Mobile Intel® 965 Express Chipset Family Graphics Memory Controller Hub (G)MCH

Specification Update

Revision 009

Section 6.3.1 Figure 10 SDVO Conceptual Block Diagram

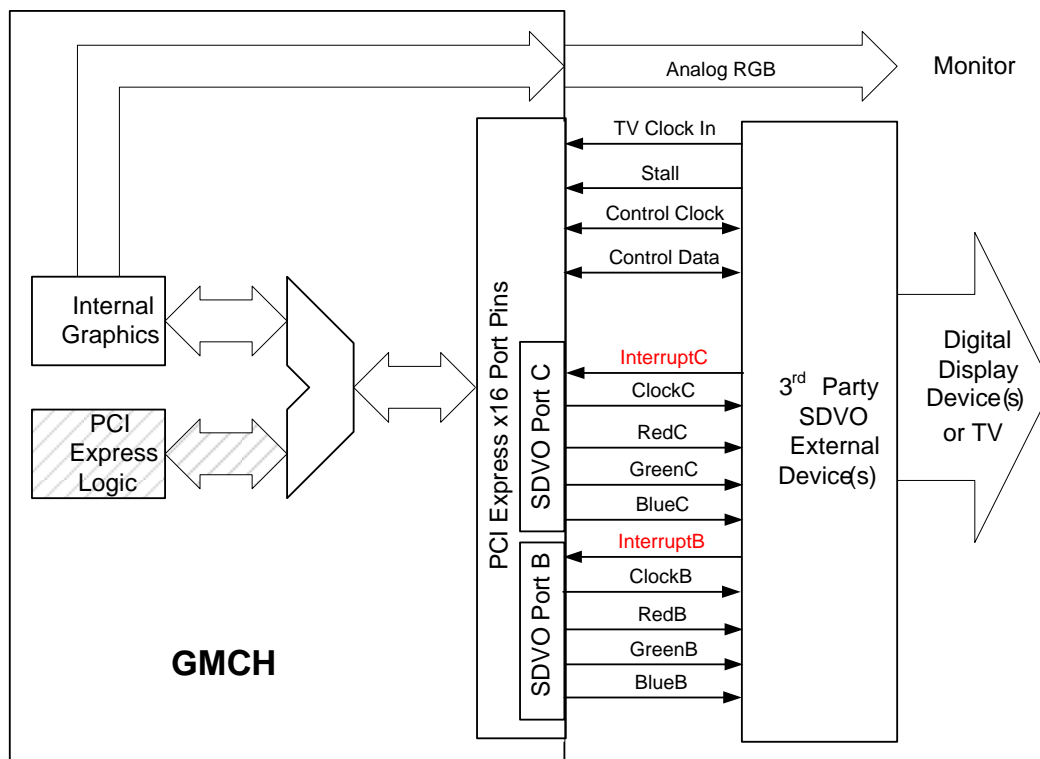
2. SDVOB_INT and SDVOC_INT Signal Naming

Changes are in RED font.
